Docket Item # 3  
BAR CASE #2009-0049

BAR Meeting  
May 6, 2009

**ISSUE:** Signage  
**APPLICANT:** Jerald J. Littlefield  
**LOCATION:** 428 South Washington Street  
**ZONE:** CD / Commercial zone

Figure 2. Proposed signage in pediment.

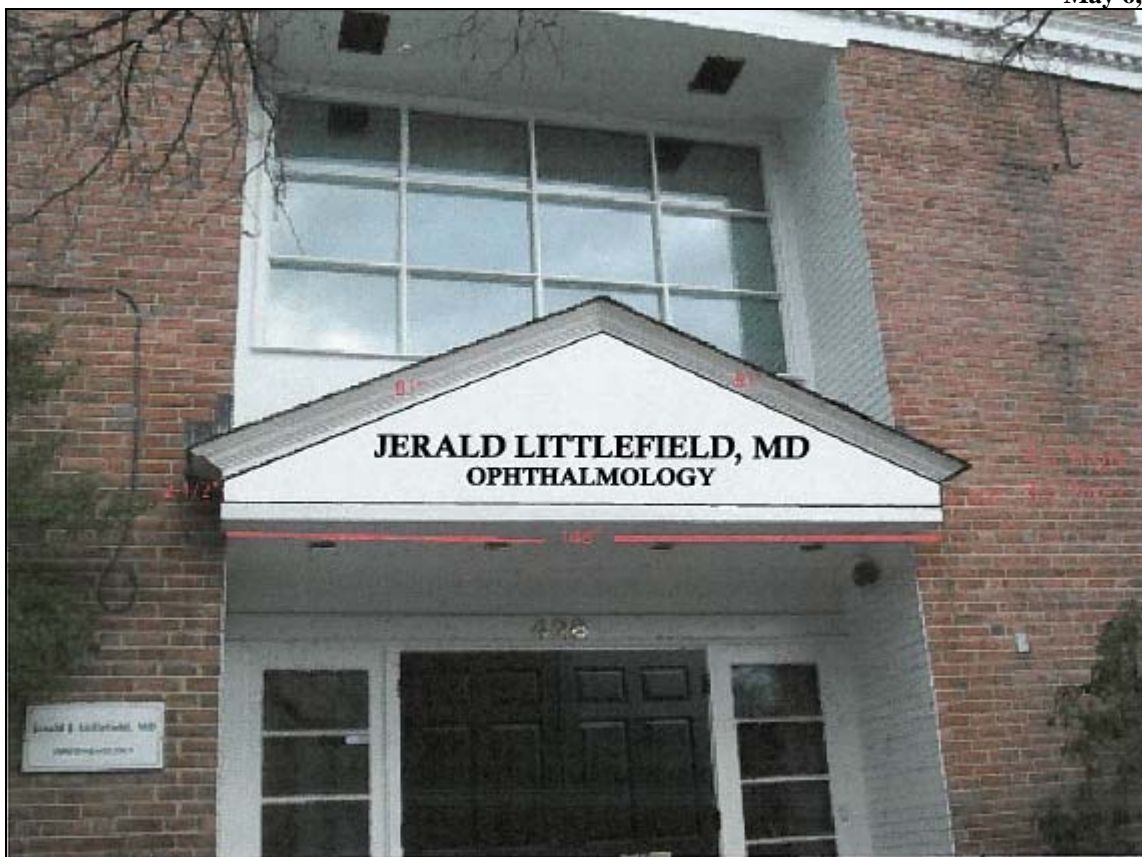
The applicant proposes to install individual letters mounted on the wood pediment over the entrance. The base of the pediment measures approximately 12 feet 4 inches. The black letters will be of formed plastic. The letters reading “JERALD LITTLEFIELD, MD” will be 4½ inches in height and the letters reading “OPHTHALMOLOGY” will be 3½ inches in height. The proposed signage will not be illuminated

In respect to the proposed signage, the *Design Guidelines* generally recommend one sign per business. The *Guidelines* also advise that “signs should not be attached to a building in a manner which requires the removal of historic materials” and “individual letter signs should be blind mounted on the front of a building.” Further, due to the building’s location on Washington Street, the proposed signage must also be compatible with the memorial nature of the Parkway. Staff finds that the proposed application for signage is consistent with the *Design Guidelines* and is appropriate for this location on the Parkway. However, Staff recommends that the letters be fabricated of metal rather than plastic and that the letters be blind-mounted. Staff has contacted the applicant who has agreed to the proposed recommendation.

C-1 Wall letters / signs must comply with USBC [H103-H111] Please indicate the method to be used for anchoring the letters to the wall.

**STAFF RECOMMENDATION:** Staff recommends approval of the application for signage with the condition that the letters be metal rather than plastic and that they be blind-mounted.
